**ADDENDUM
NO. 2**

Richland Bean Blossom Schools Roofing & Mechanical Renovations
Various Schools Locations
Ellettsville, IN 47429

PROJECT: Richland Bean Blossom – Roofing & HVAC
Junior High School

DATE OF ADDENDUM: February 10, 2026

ROOF DETAILS

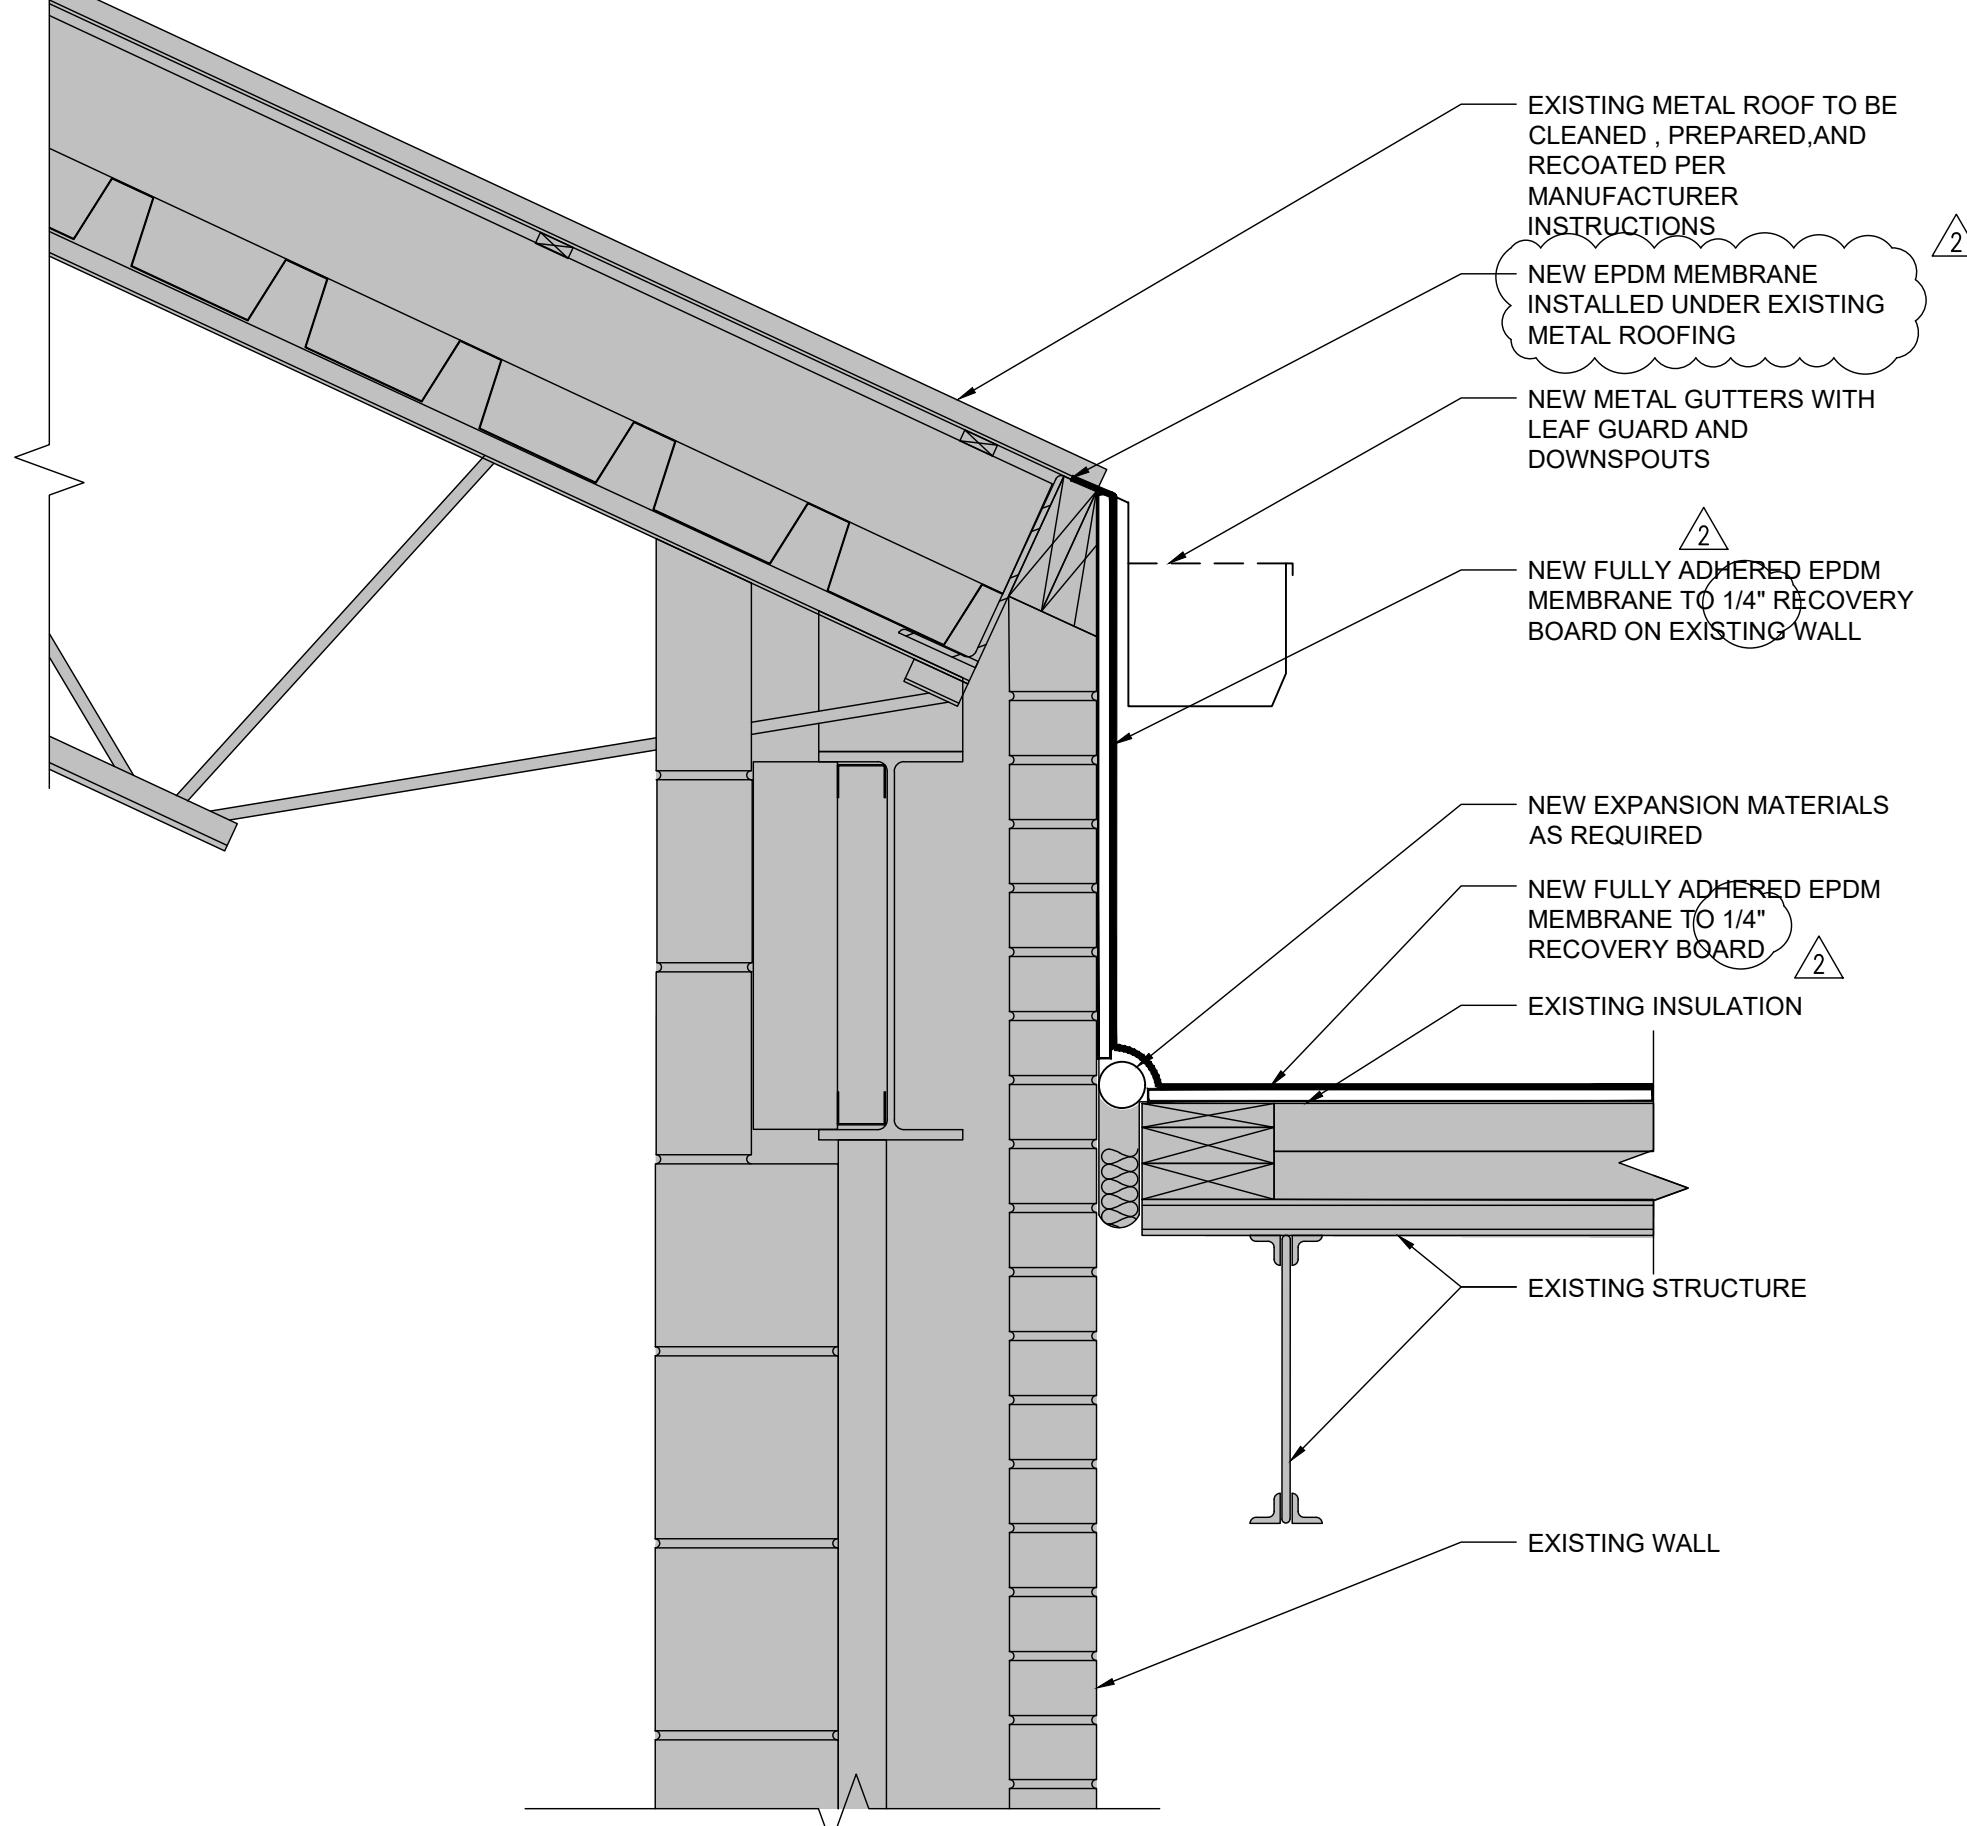
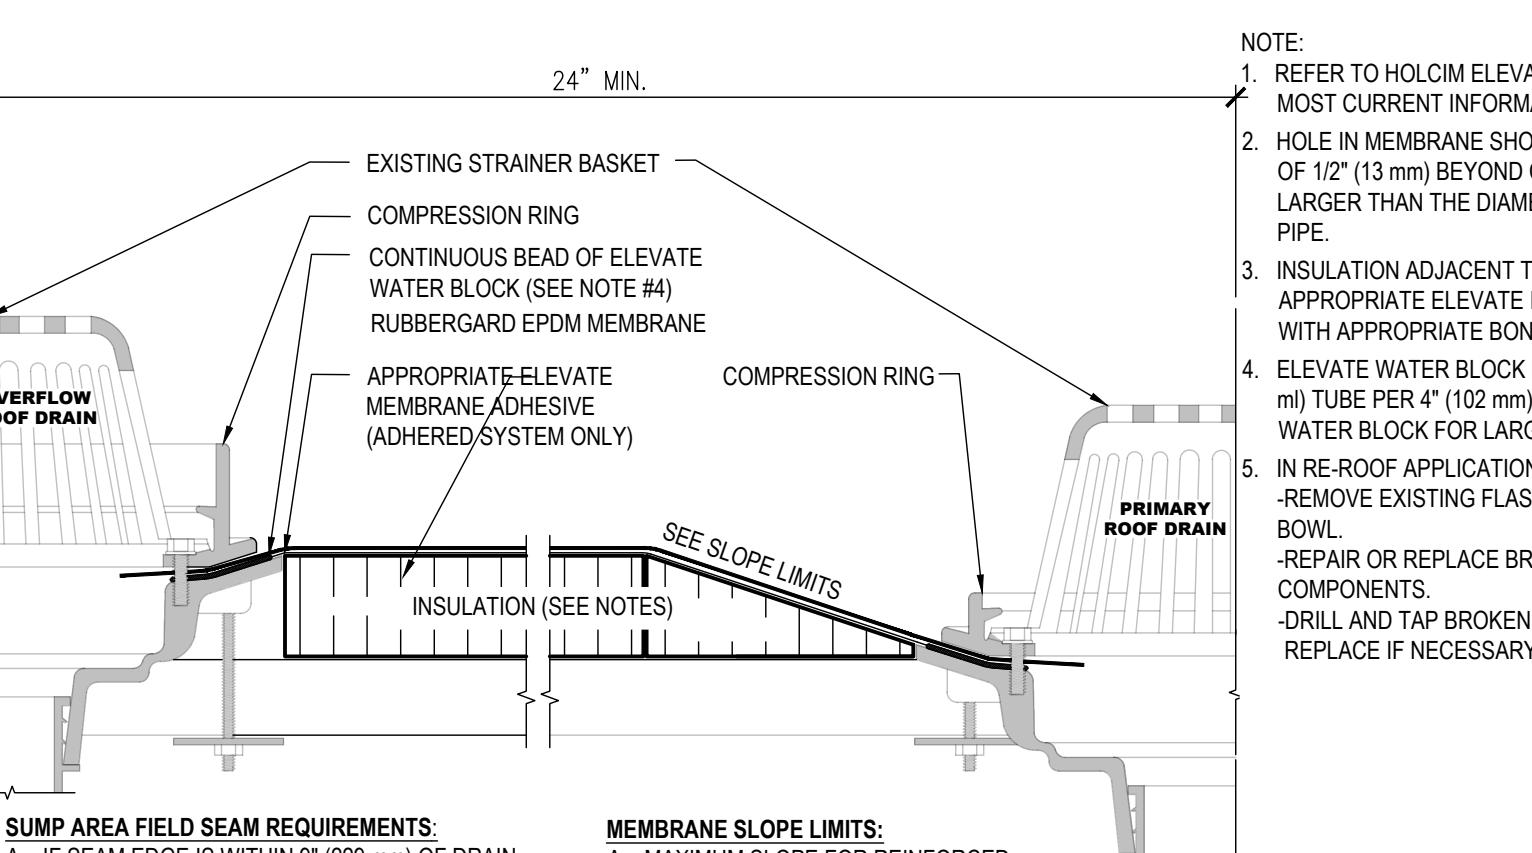
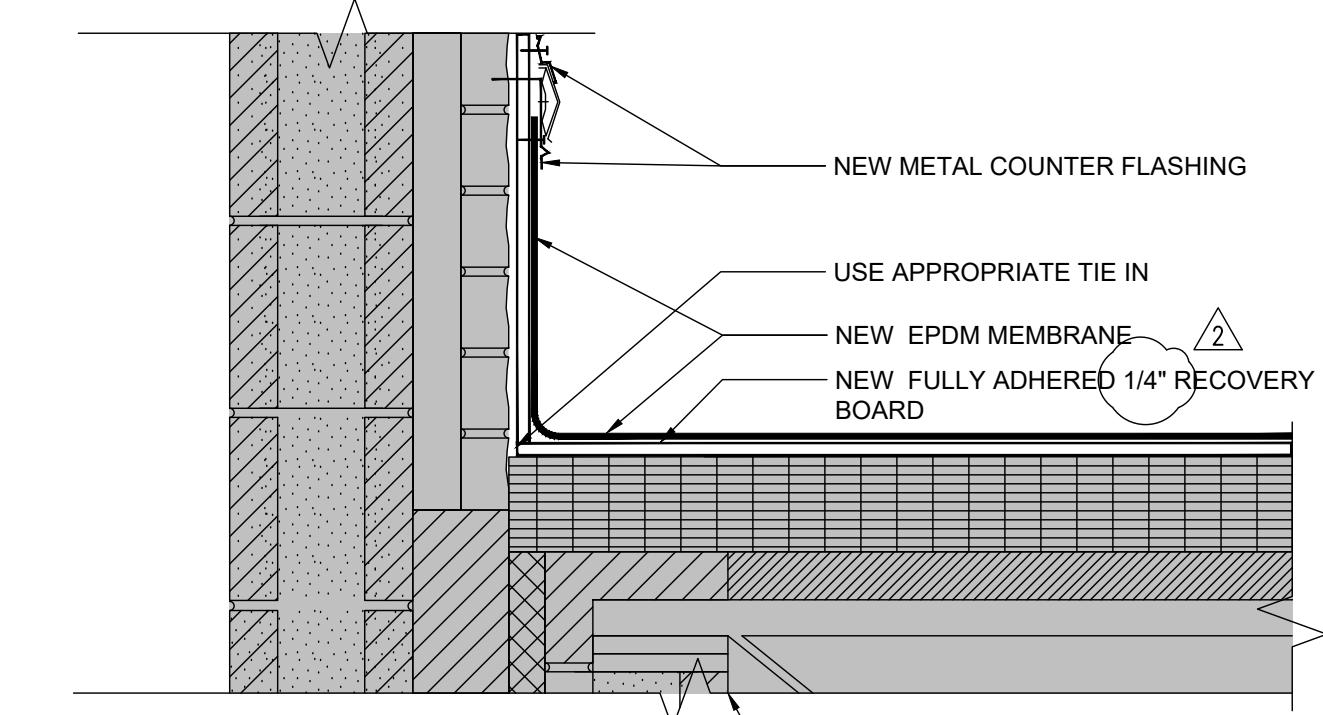
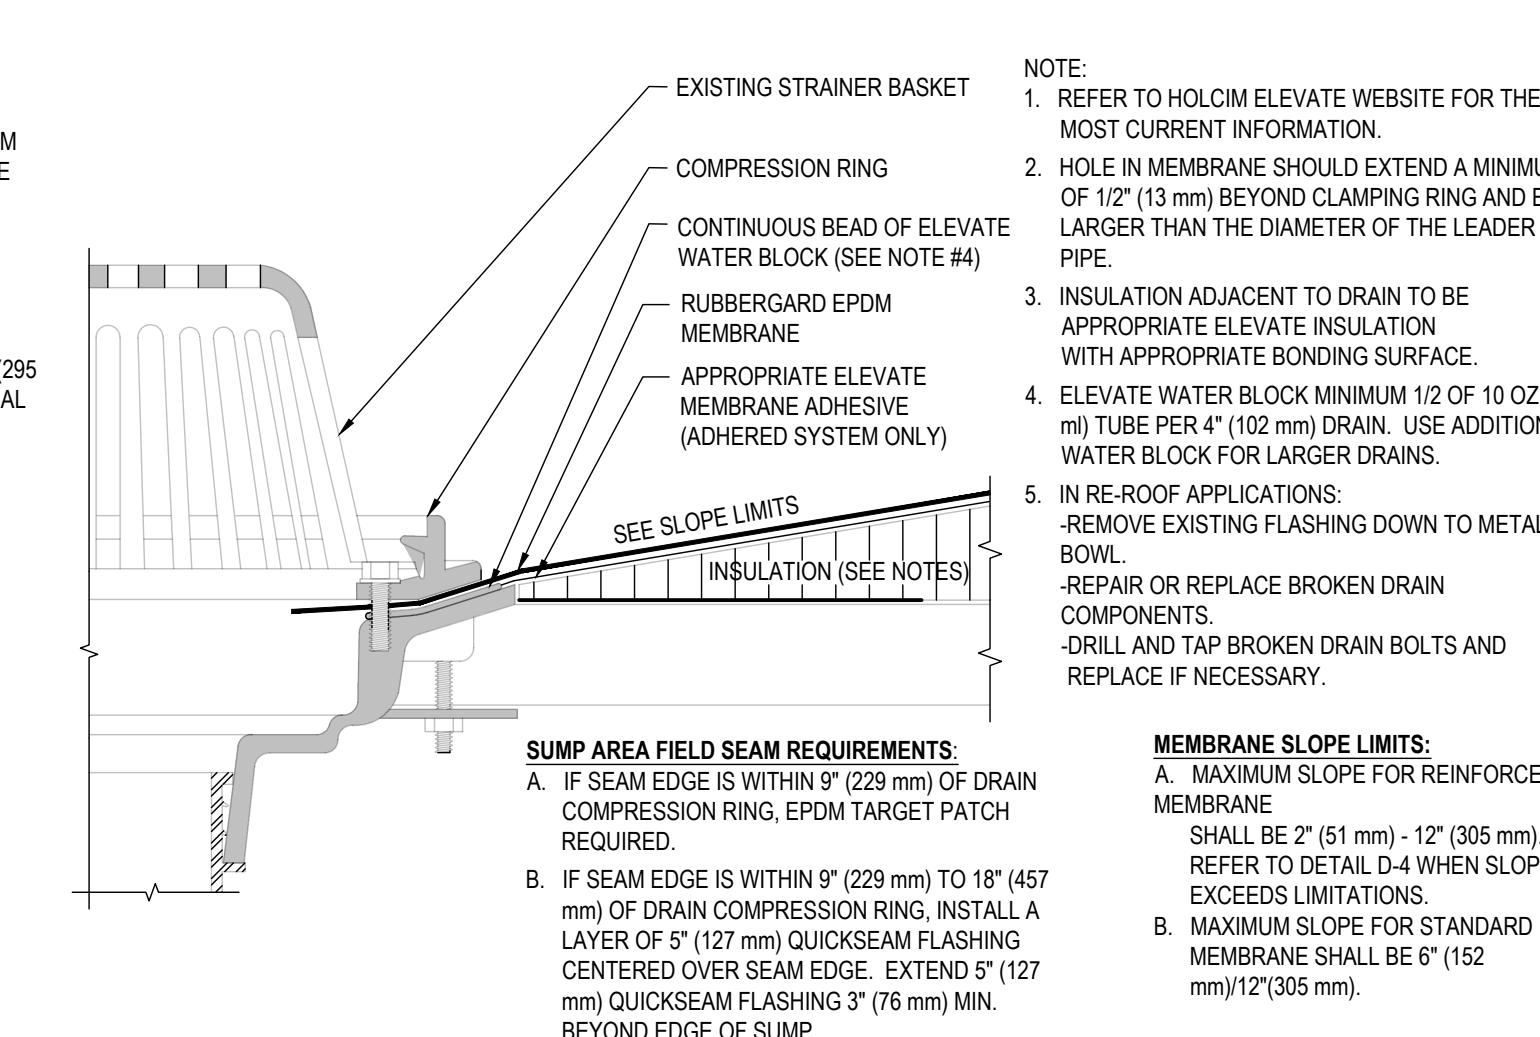
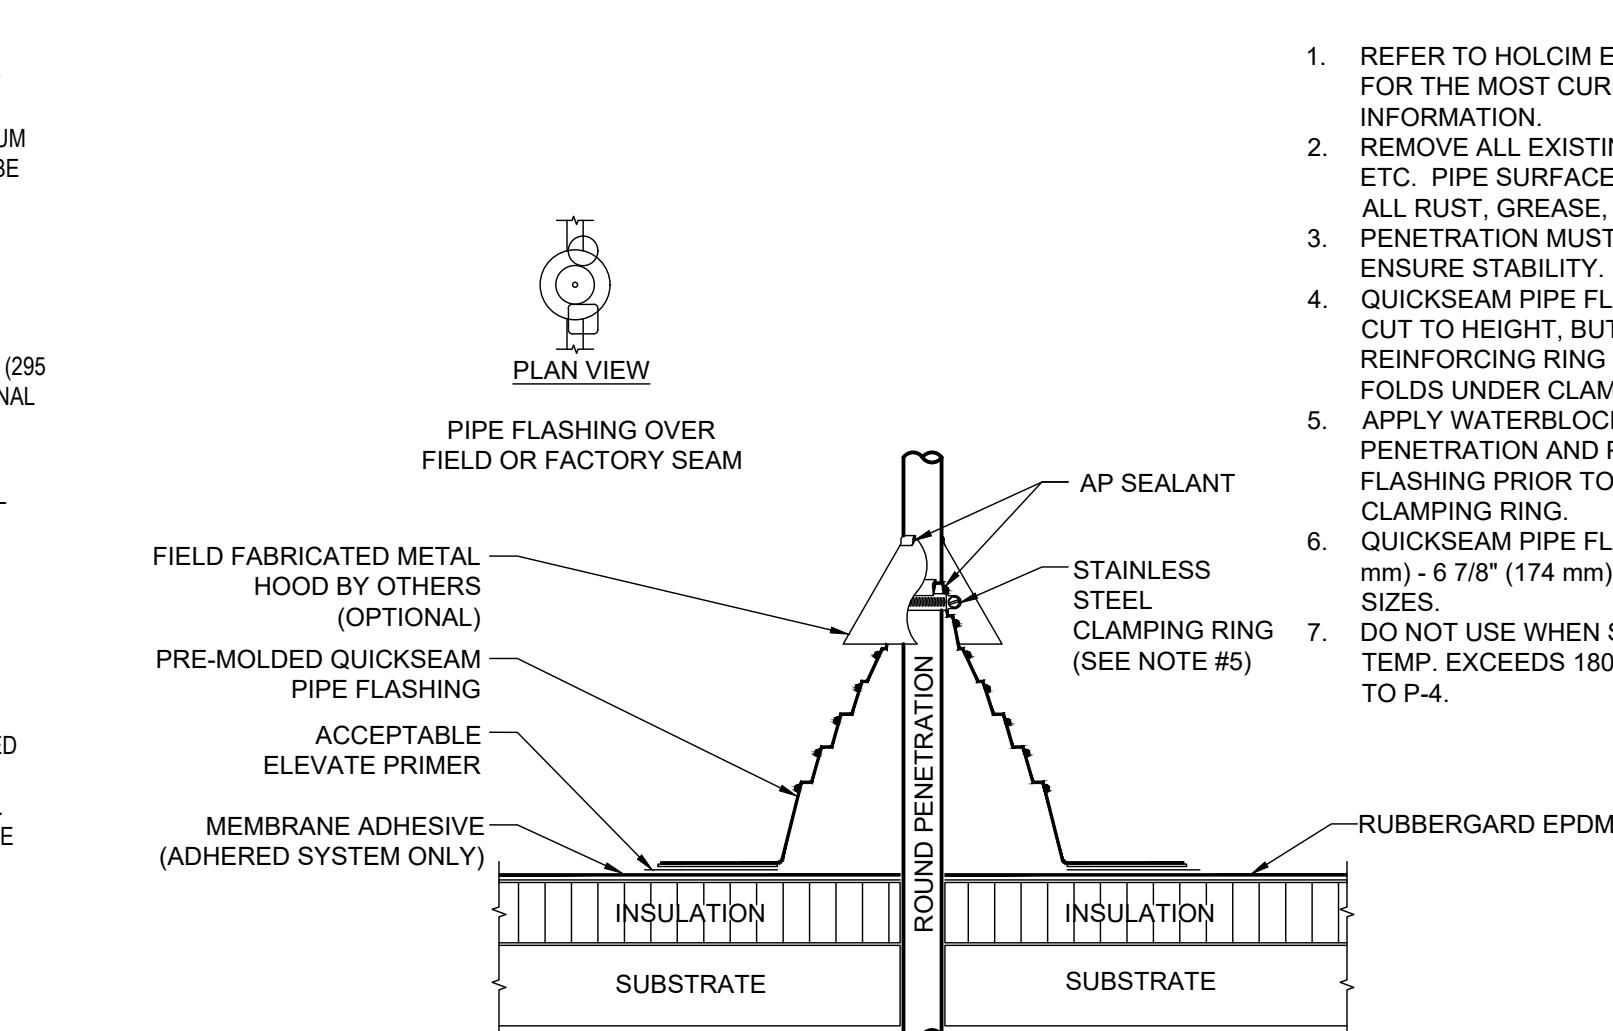
- All the recovery board shall be 1/4 inch thick.
- All parapet coping shall be new.
- New roof membrane shall be installed vertically and continue under the existing metal roof.
